Subject: Enrico Fermi Atomic Power Plant, Unit 2,
Docket No. 50-341
Responses to NRC Environmental Review Questions

A.4 RESPONSES TO NRC ENVIRONMENTAL REVIEW QUESTIONS

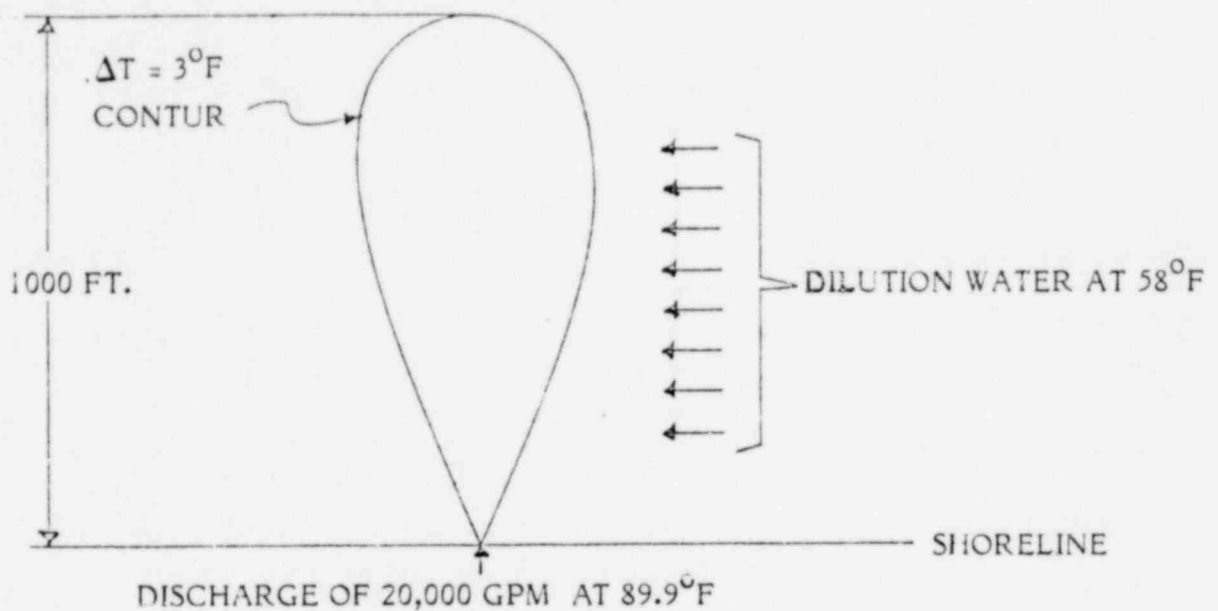
6. (Section 2.7.1.2 and Appendix A.2-Item 350.5) In the discussion on Eutrophic Impact in Subsection 5.1.2.2.6 it is stated that "the discharge water will be rapidly diluted and distributed in the lake." What is the basis for this statement? Since the bottom does not slope much and the water is shallow in the vicinity of the plant it would seem that the rates of water exchange between the water body adjacent to the plant and Lake Erie as a whole would be relatively slow. Can calculations be made which compare this exchange rate to the volume rate of discharge to the lake? Provide proper revised text for Item 250.5 (September 22, 1978).

From Table 1 it can be seen that the discharge concentration of either temperature or dissolved solids will be reduced to 50 percent within 200 feet of the discharge point and to 10 percent within 1000 feet of the discharge point. This rapid decrease in concentration of either temperature or dissolved solids justifies the statement. "The discharge water will be rapidly diluted and distributed in the lake."

The lake bottom at the discharge location slopes away from the shoreline at an approximate slope of 1:180. The water depth 1,000 feet offshore of the discharge point would be 7 feet. Referring to the sketch below which depicts Case 3, an extreme case; (i.e. large discharge and ΔT , lower than existing MWL of 572, and dilution from one side of the plume) the lateral velocity required to provide the required plume dilution water would be approximately 0.1 foot per second.

For a lake level of 575 feet, a discharge of 10,000 gpm, a ΔT of 31.9°F, and entrainment of dilution water from both sides of the plume (Case 5 in the Environmental Report) the required lateral velocity would be less than 0.02 fps to dilute the plume to a ΔT of 3°F. Typical values for the lateral velocity at the Fermi power plant site range between 0.4 and 1.0 fps.
